The Regular Meeting of the
Brian Head Planning Commission
Town Hall - 56 North Highway 143 - Brian Head, UT 84719
Zoom Meetings ([Click Here](#))
Zoom Meeting ID# 840 1848 0649
TUESDAY, December 3, 2024 @ 1:00 PM

ITEM: ROCKY MOUNTAIN POWER BUILDING/GRADING PERMIT

PROPERTY: 512 N. HIGHWAY 143,
PARCEL #A-1138-0007-0000 AND SA-A-1138-0030-0000

BRIAN HEAD SUBSTATION
IRON COUNTY, UTAH
GRADING PLAN
SITE DEVELOPMENT PLAN

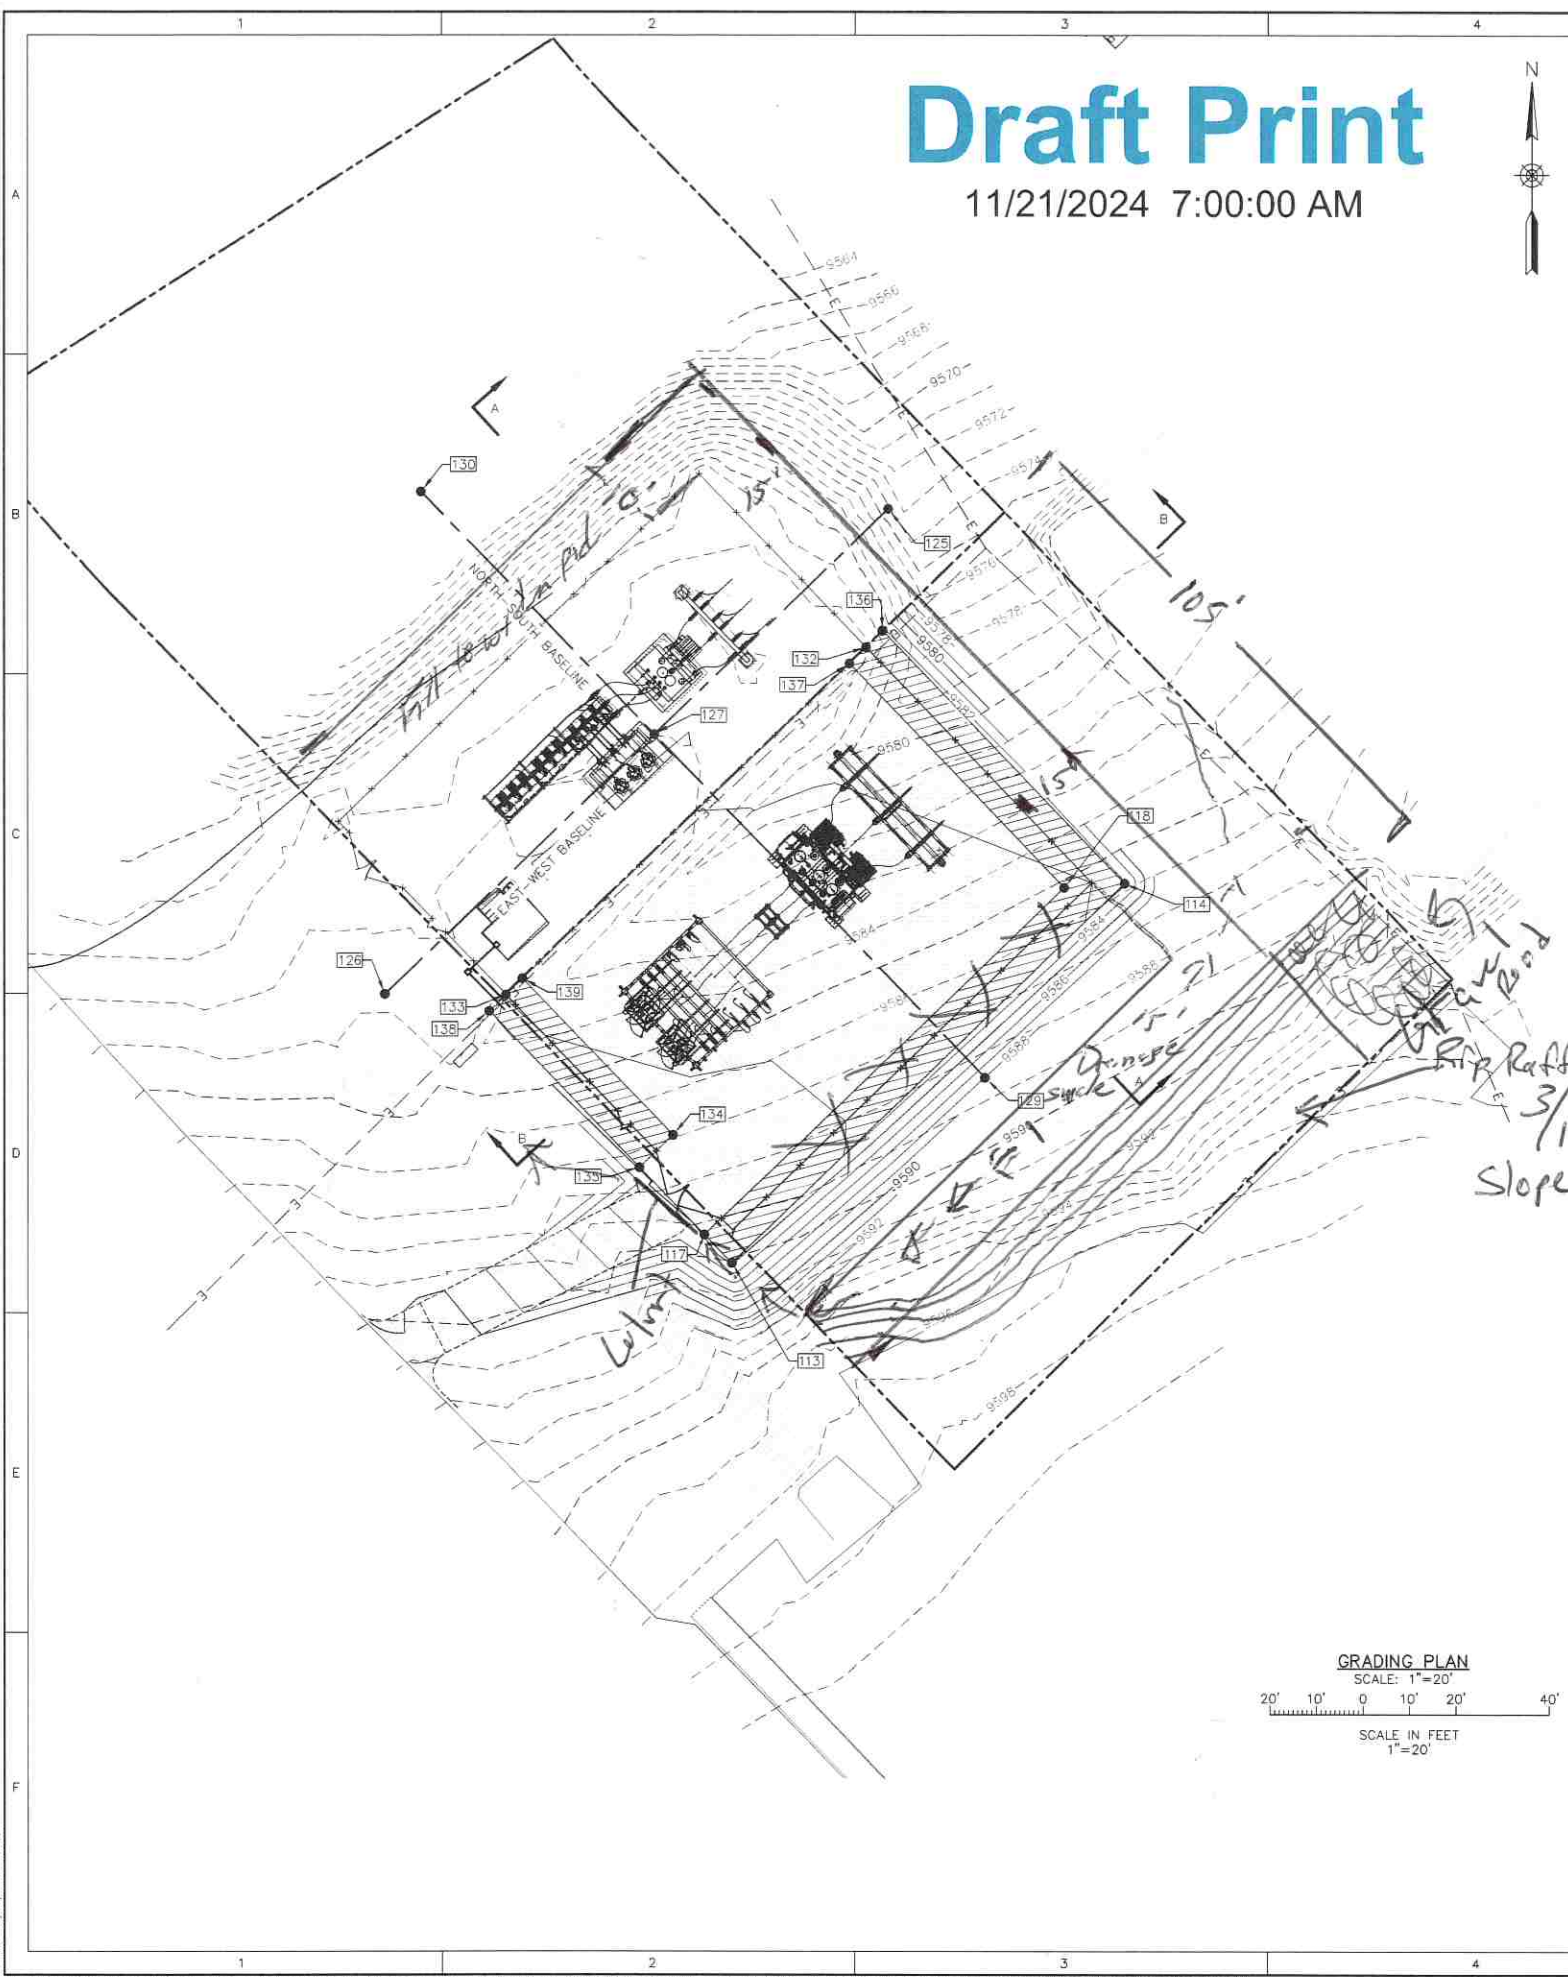
The Grading Plan is attached for review. The following Findings of Fact are based on RMP's submittal for the Building/Grading Permit:

1. The grading, excavating, trenching, and clearing being proposed unfortunately is to clear the entire site of trees. This is required for safety reasons, i.e. trees falling onto the transformers, etc. and in keeping people out of the site. The grades and elevations of the site are already set by the existing substation. The site will be brought to a finished elevation of the existing substation. This will require both cut and fill.

4. Quantities to be removed from or brought to the site. – The site upon which this work will take place is 1.01 acres. There has been approximately 145 cubic yards of organic material removed from the site to date. There will be approximately 432 cubic yards of cut with approximately 163 cubic yards of imported fill. The site will be graded as to control all drainage and runoff.

5. Plan for storage and disposal of materials. – Most of the cut material will be hauled off. Some material will be used for the ramp at the east corner next to Apple Annies. This ramp will be used as access to the substation. Other materials that will be used from the cut material are rocks and boulders that will be used along the common property line with Apple Annies as a stone retaining wall.

7. Screening – Applicant has verbally agreed to use a decorative concrete wall that will meet Town standards to enclose this project.
8. There are 2 sites that are owned by RMP. This subject site is 1.01 acres, and the existing substation sits on .53 acres and has approximately 50% open space associated with it. Staff would suggest that the property line between the 2 parcels be vacated so that the overall site is 1.54 acres and the open space requirement will be met.

After reviewing the plans and meeting with representatives of RMP and Bulloch Dirt Works, it is the recommendation of staff to approve this Grading Plan based on the Findings of Facts and with the following conditions:

1. All work to follow the Grading Plan as submitted.
2. All measures to mitigate erosion, noise, dust smell and safety to be followed as outlined in the LMC.
3. The new site will be screened by a decorative concrete wall, the design of which will be agreed to by both RMP and Brian Head Town. Wall to be completed by the time the generators are installed in the spring of 2025.
4. RMP will vacate the property line between the 2 parcels so that the larger 1.54 acre parcel meets the zoning requirements.
